**SUBJECT: BILLS 136 (2025) AND 137 (2025), RELATING TO THE  
RENOVATION OF 60 SOUTH CHURCH STREET, WAILUKU,  
HAWAII (BFED-8)**

**PROJECT:** 60 S. Church St.  
**SUBJECT:** Waterproofing

**SUBJECT: MOISTURE REPORT – 60 S Church Street-Lower Roof**

Exhibit -1

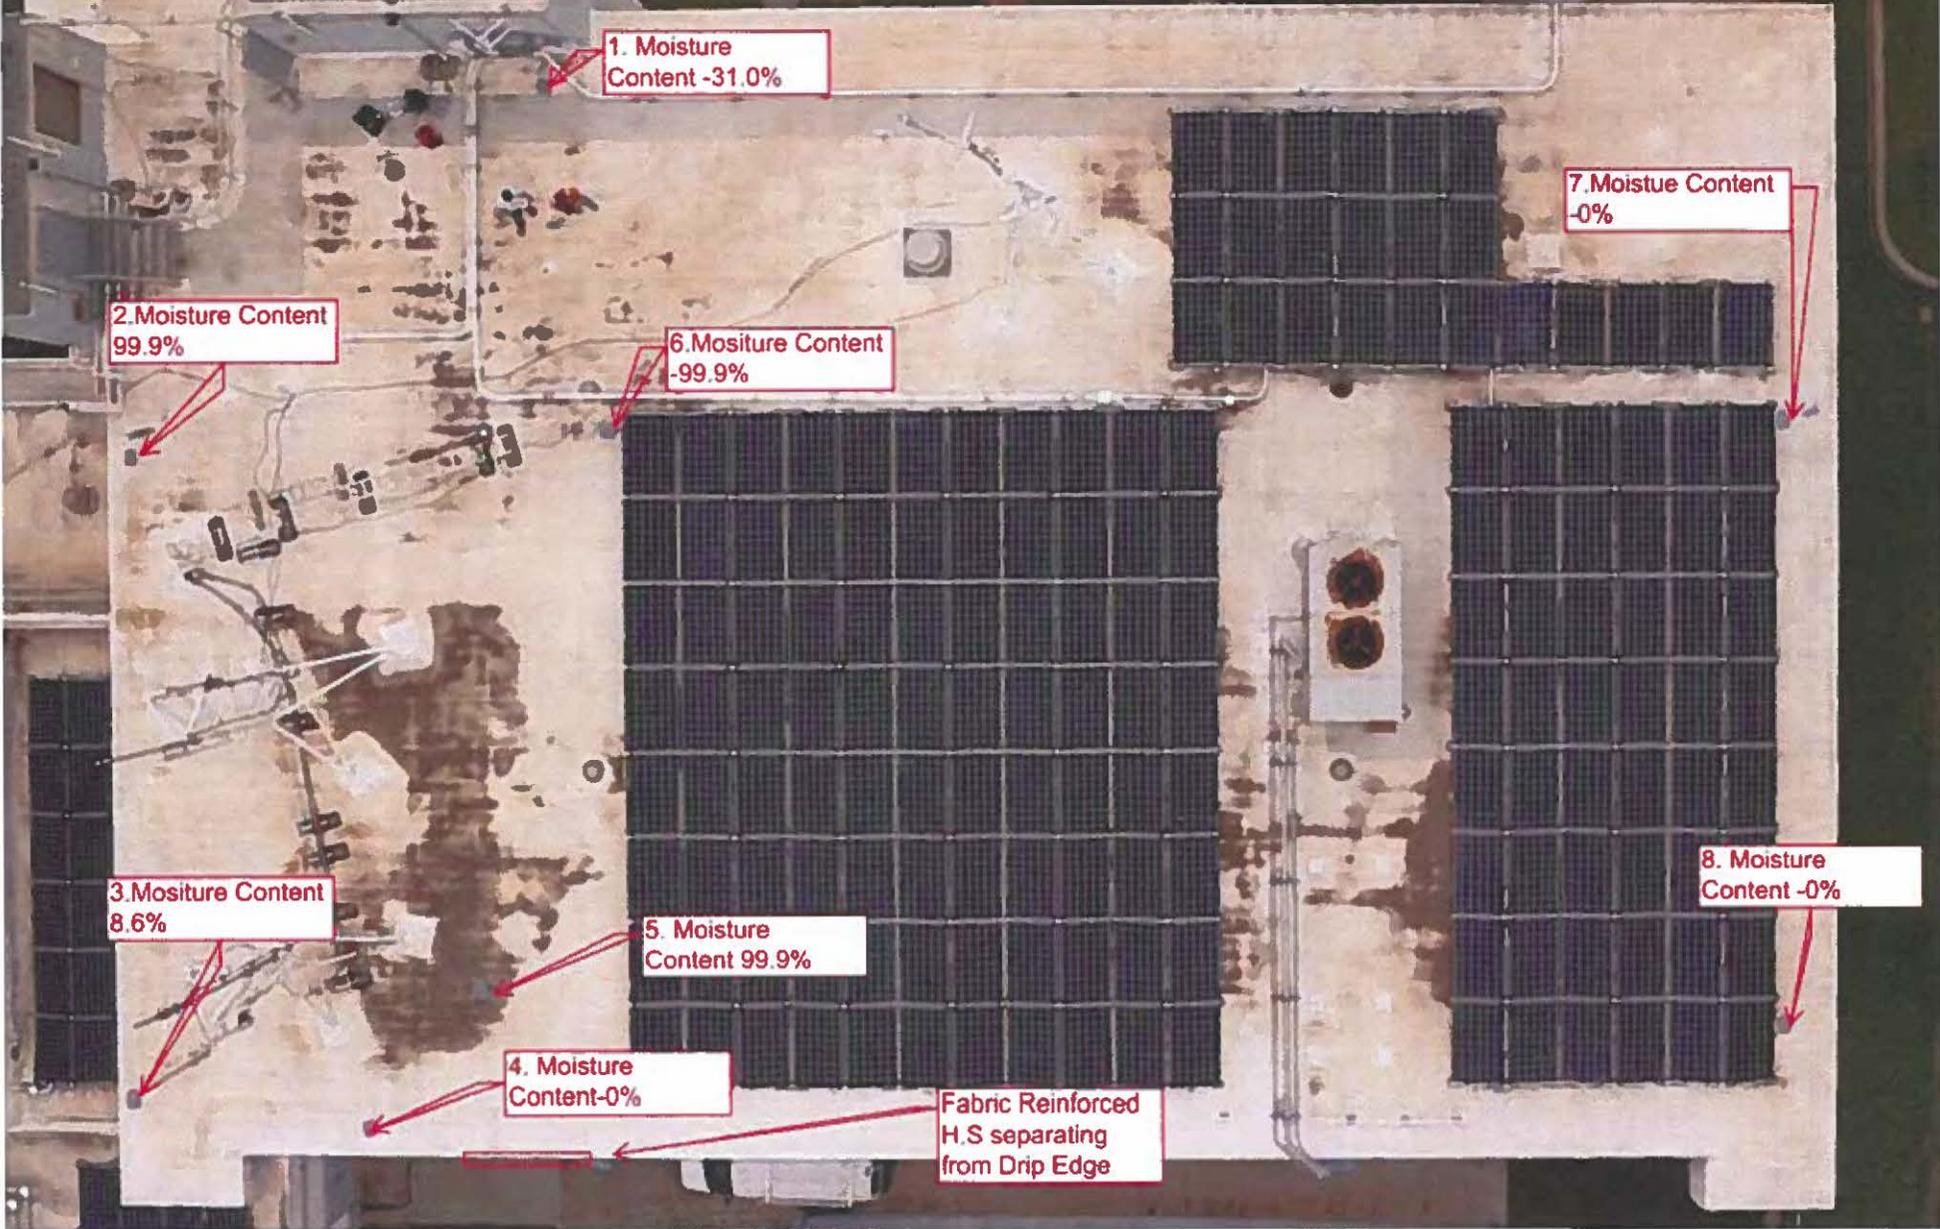
DS Q: Why wasn't the NW exposed roof area (between the PV panels) looked at or tested for moisture?

ADL: We took 8 core samples of the roofing, which, when we were planning the work, seemed like a good representative sampling of the roofing condition. Of course, we could have had more taken but in our planning we thought 8 was adequate. If the County wants more taken, we can arrange that.

8  
9-4
EXTERIOR BEAM SECT.  
3/4" = 1'-0"

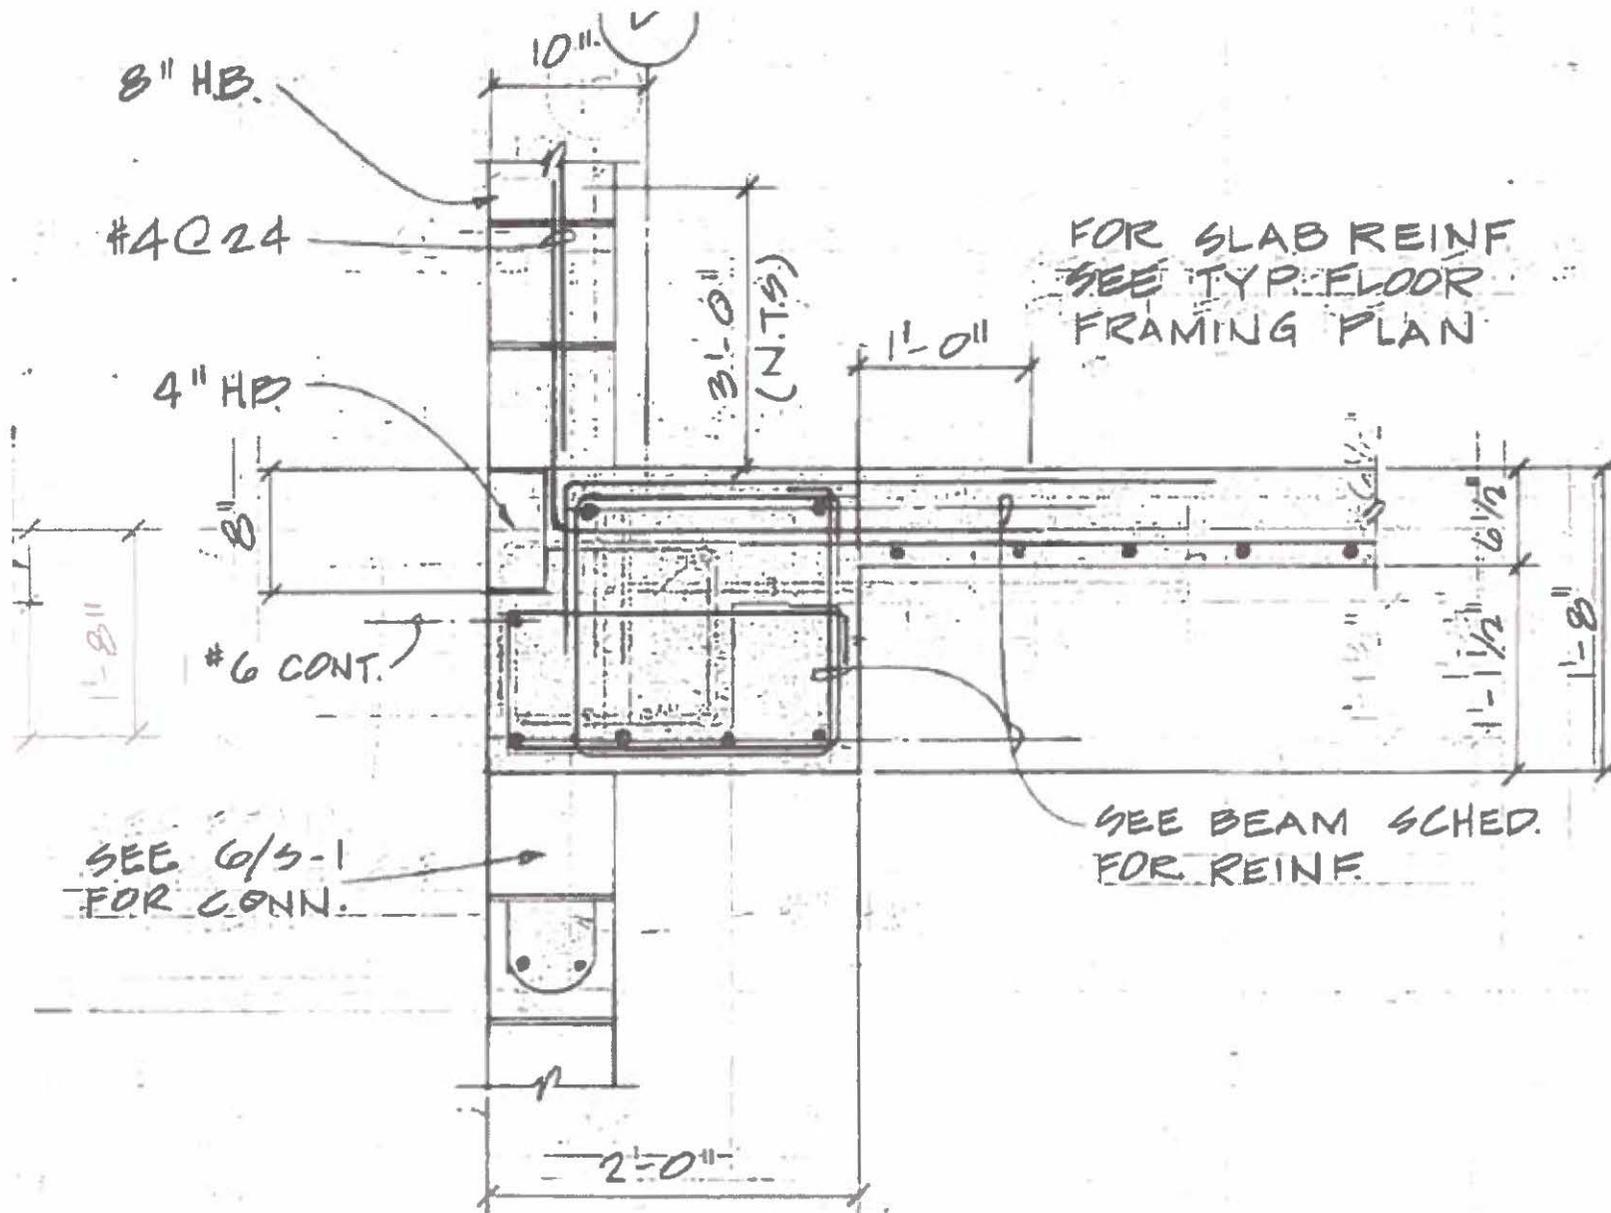
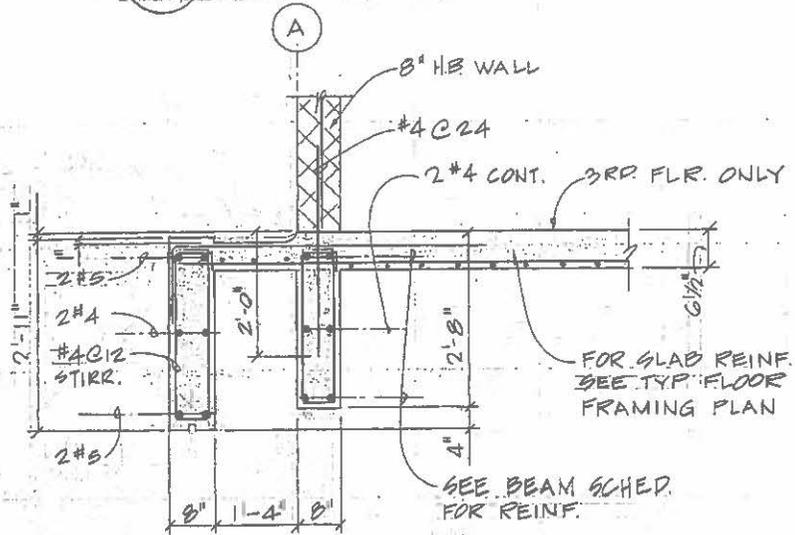
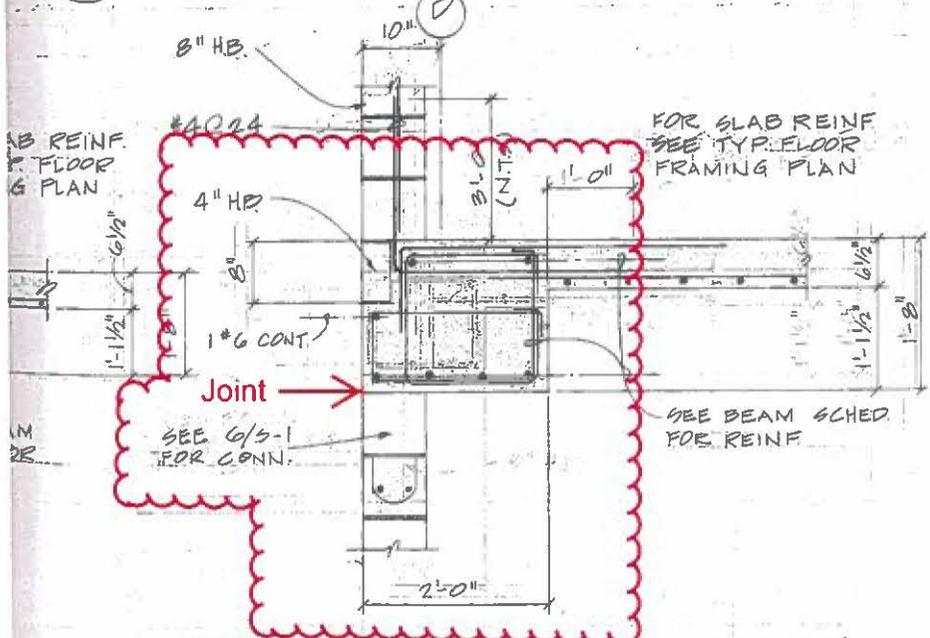
3.1.3 The scored CMU starts 8" below the floor line and extends to the underside of the beam above. To accomplish this, the top of the horizontal concrete beams has a 4" wide x 8" high blockout at the top of the exterior side. A 4" thick block (½ a block) is placed in the blockout, apparently to maintain the 5-score block pattern. Because the bottom of the CMU wall sits in an "L" shaped concrete pocket, it's a watertight condition (see Detail 8/S-4 Exhibit 4).

The detail between the top of the infill wall and the bottom of the beam above, however is considerably less watertight. According to the construction drawing detail at the top of the 1<sup>st</sup>, 2<sup>nd</sup> and 3<sup>rd</sup> floor walls, the CMU walls were built two block courses short of the bottom of the beam above. The vertical reinforcing was then inserted into the empty cells and the grout installed thru the opening left by the missing top blocks. A horizontal bond beam was then constructed along the top of the wall (the next-to-top course) with the horizontal rebar and grout inserted thru last missing CMU course. The top block course was then constructed with a half block on the face and hand-placed concrete on the inside, with an inside form. The installation of that last block course is very difficult and requires careful attention. It is very likely the source of the water coming thru the wall (see joint details - Exhibits 4, 5, 6 & 20).

Exhibit 20

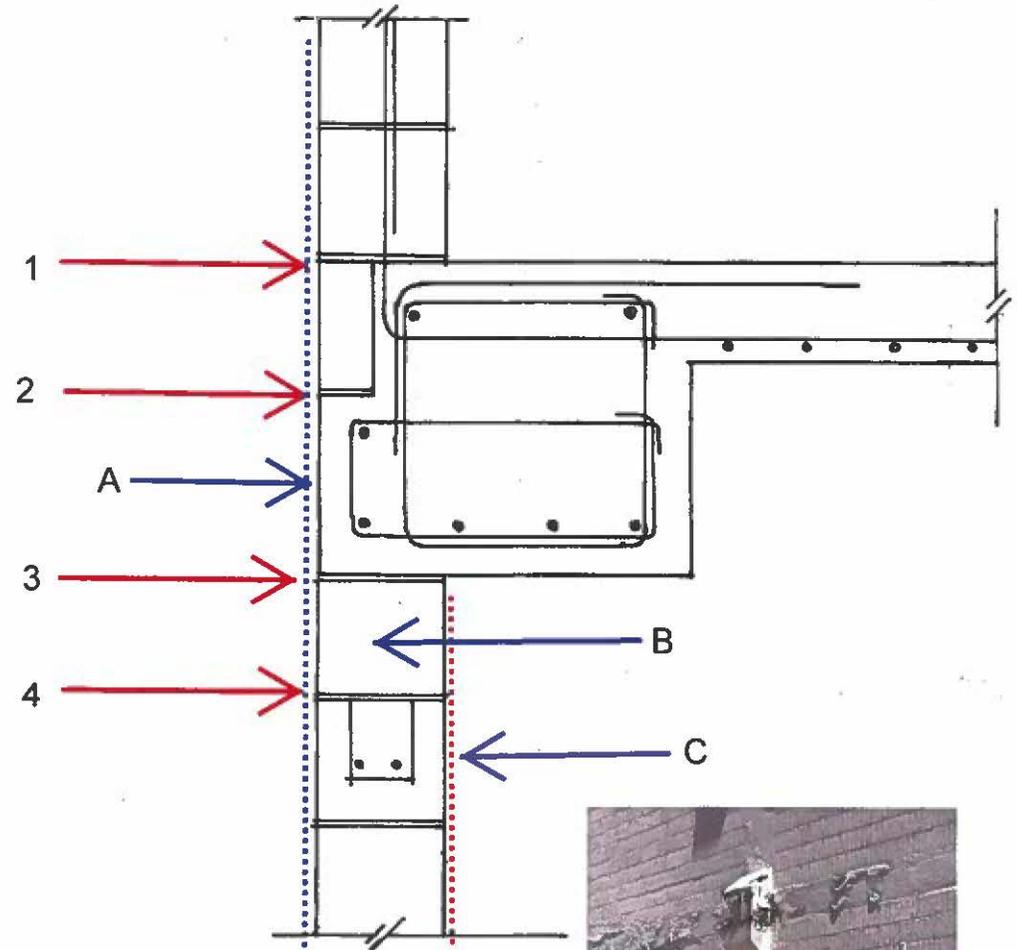
- A - Remove blistered paint on concrete columns and beams.
- B - Destructive investigation by drilling holes in the CMU block to determine if the block is filled solid with grout or hollow. Also exploratory investigation of a small section of wall to test ejecting polyurethane grout. We do not know if the CMU walls were constructed prior to pouring the floor and beam?
- C - Remove cement wash and apply Thoroseal, Mapei or Sika waterproofing material on the interior of the block wall above the existing grid ceiling. The cement wash has visible cracks and efflorescence (see photos Exhibits 11& 12).

At joint conditions 1, 2, 3 & 4:

- Grind and remove the existing mortar joints to a depth of  $\frac{1}{2}$ " -  $\frac{3}{4}$ "
- Clean surface area with air, not water
- Apply Mapei product - Mapeflex P2NS sealant
- Smooth surface and do not to cover the flutes of the CMU block
- Apply 1 coat of Mapei Primer AR and
- Apply 2 coats of Mapei Elastocolor-Coat
